VILLAGES AT STERLING RANCH

CONSTRUCTION PLANS

NOVEMBER 2024

V1_Construction Drawings (Plans-Profiles).pdf Markup Summary

VILLAGES AT STERLING RANCH			
CONSTRUCTION PLANS			
TITLE SHEET			
DESIGNED BY	EAS	SCALE	DATE 11/01/2024
DRAWN BY	EAS	(H) 1" = 150'	SHEET 1 OF 25
CHECKED BY	(V)	1" = N/A	JOB NO. 1183.26

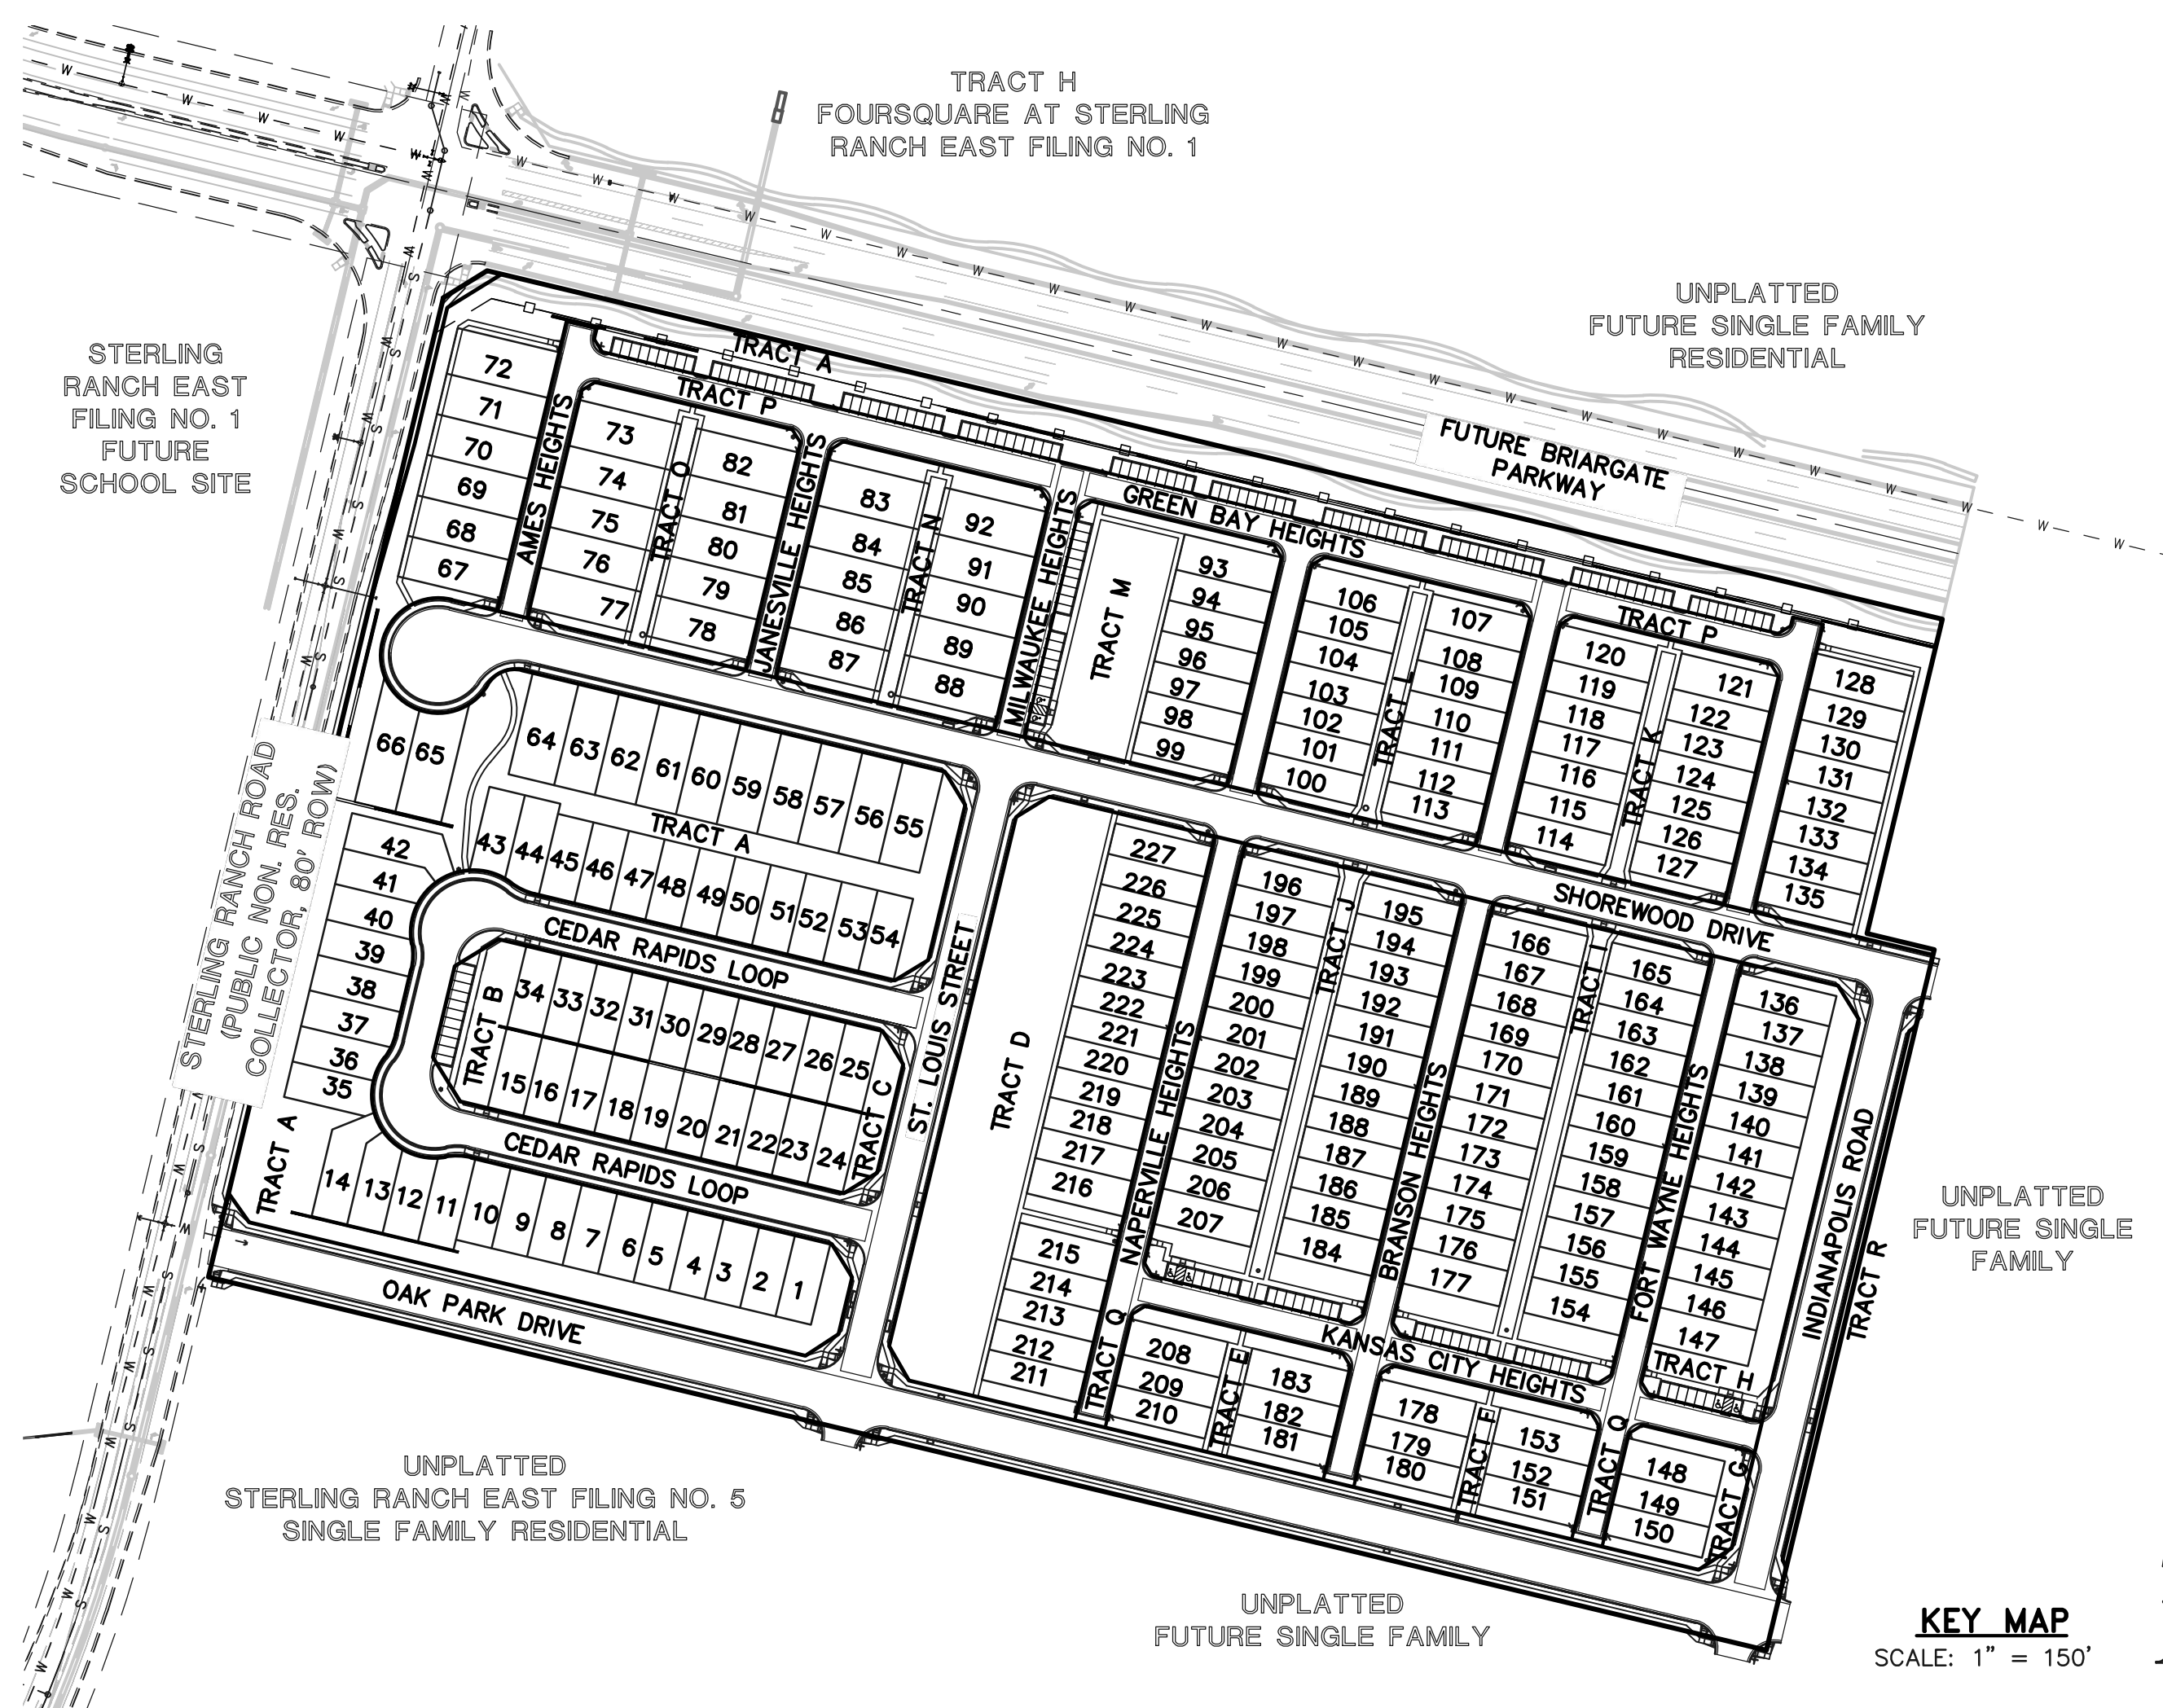
Remove as Utility Plans are a stand alone set with their own cover sheet.

VILLAGES AT STERLING RANCH
STREET IMPROVEMENT PLANS
OAK PARK DRIVE

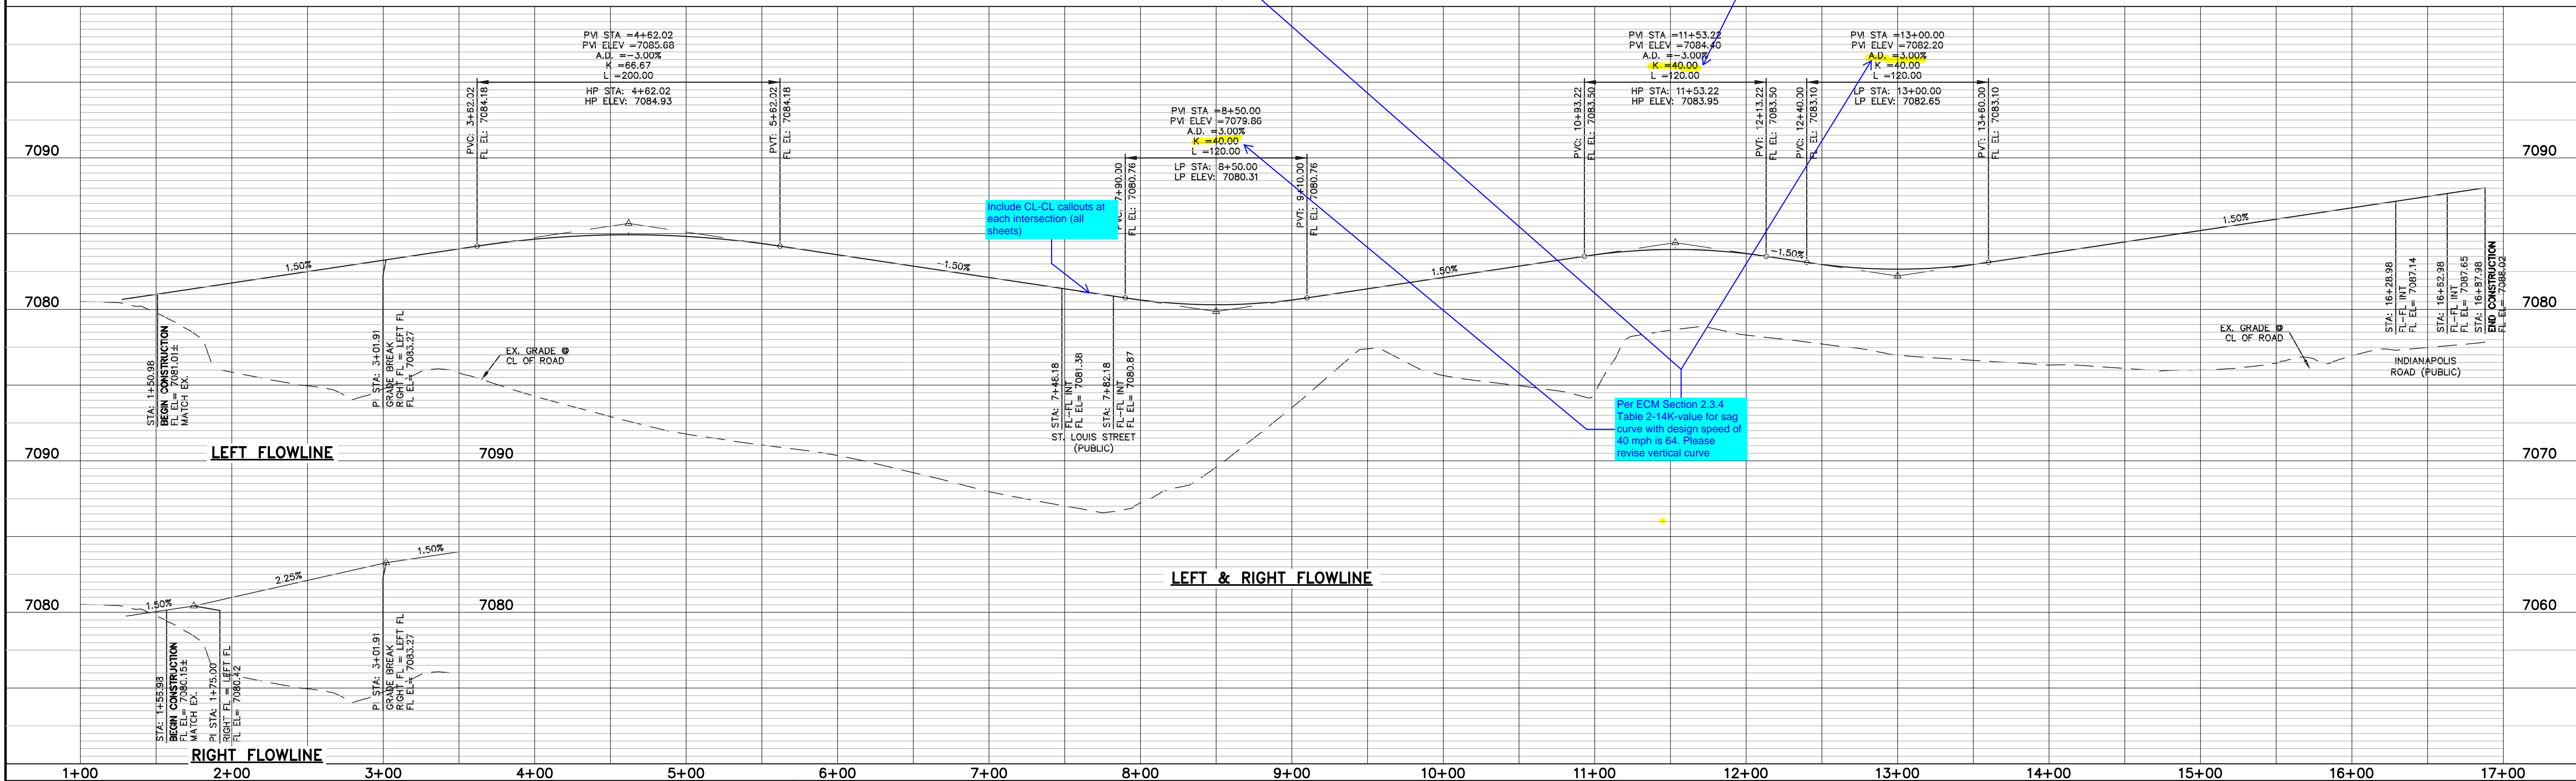
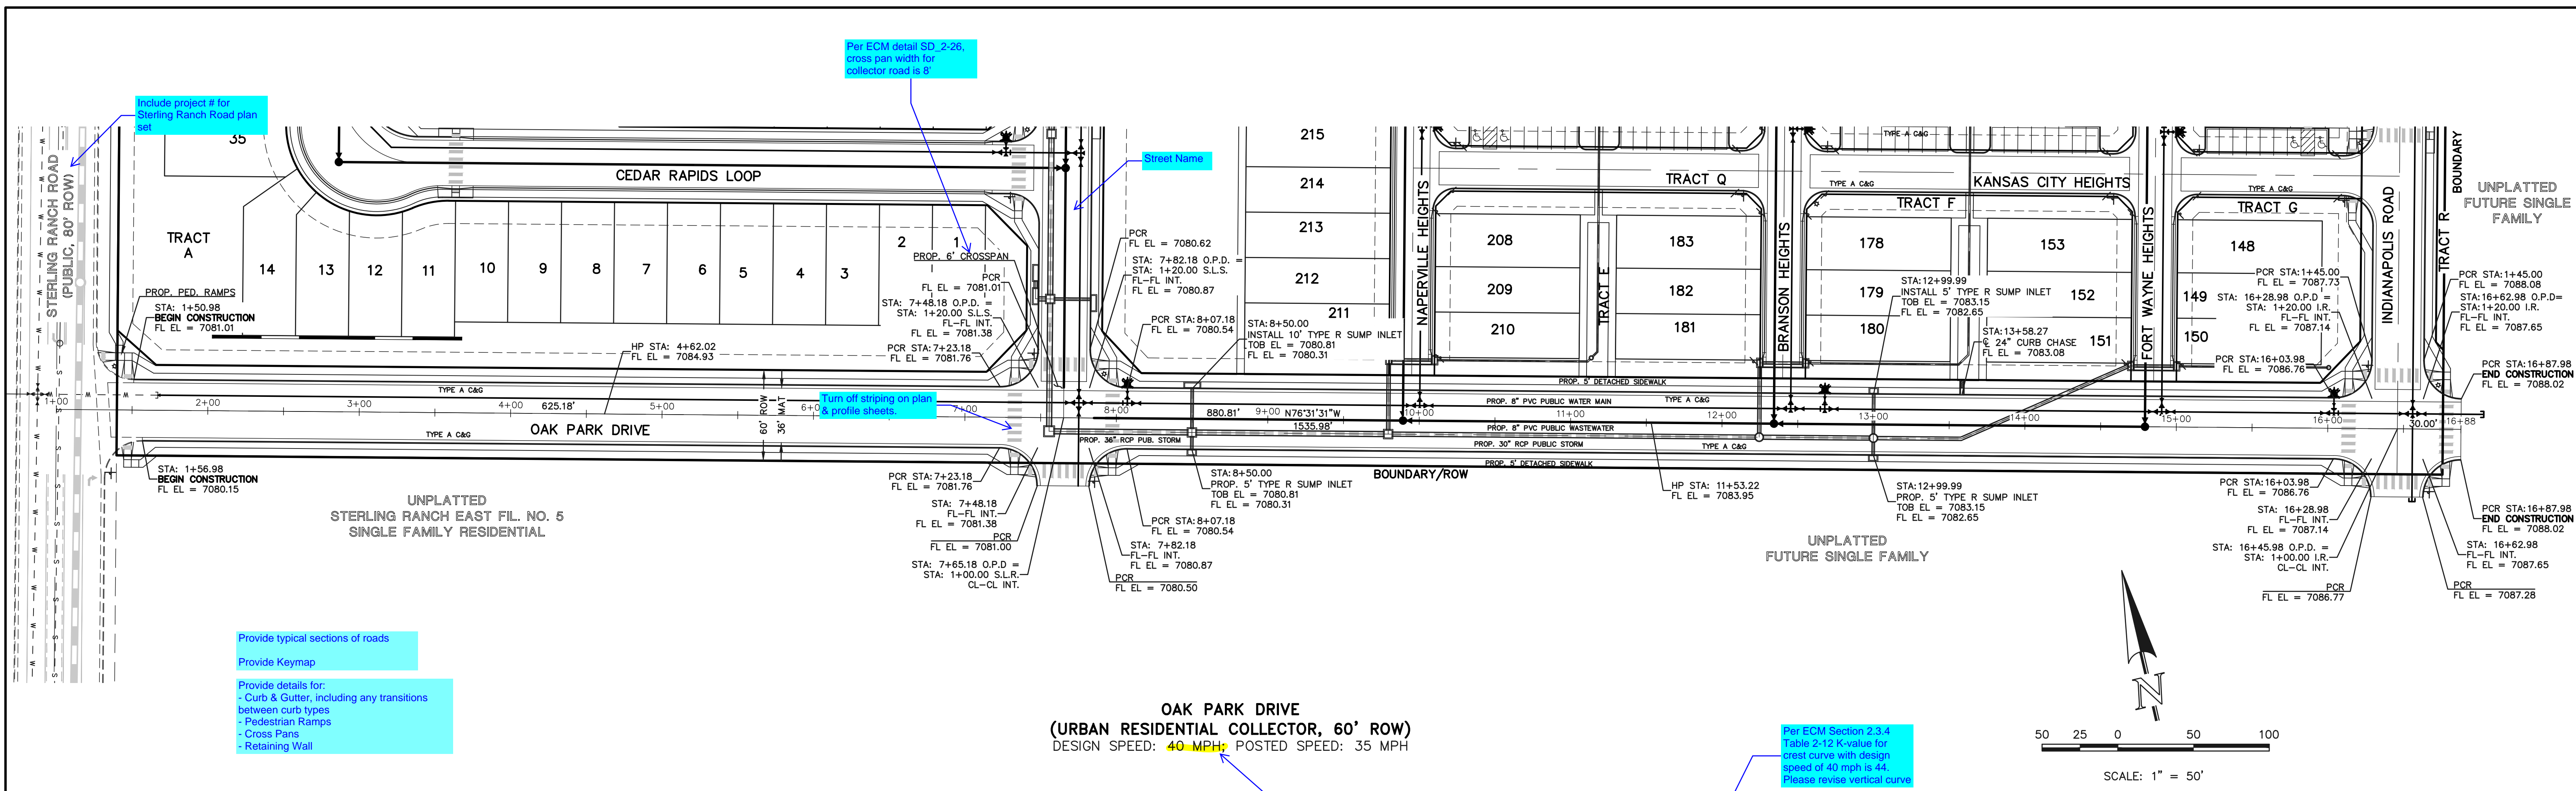
- Provide typical sections of roads
- Provide Keymap
- Provide details for:
 - Curb & Gutter, including any transitions between curb types
 - Pedestrian Ramps
 - Cross Pans
 - Retaining Wall

Per ECM Section 2.3.4
 Table 2-12 K-value for crest curve with design speed of 40 mph is 44.
 Please revise vertical curve
